X 96.006-26

Model 250PS

New top section

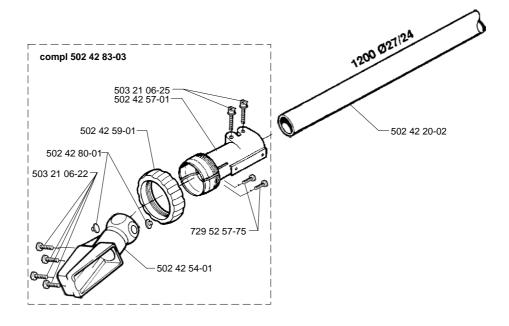
A new, lighter top section has now been introduced for the shaft lengths 5 and 6 metres. The following applies to older models fitted with aluminium top sections:

When replacing the attachment 502 40 47-02 with the ball-joint compl. 502 42 83-03 the sleeve on the shaft top section 502 42 30-04 must be cut off.

When replacing the shaft top section 502 42 30-04 with shaft top section 502 42 20-02 the attachment 502 40 47-02 must also be replaced with the ball-joint compl. 502 42 83-03. These components together are cheaper than just the shaft top section 502 42 30-04.
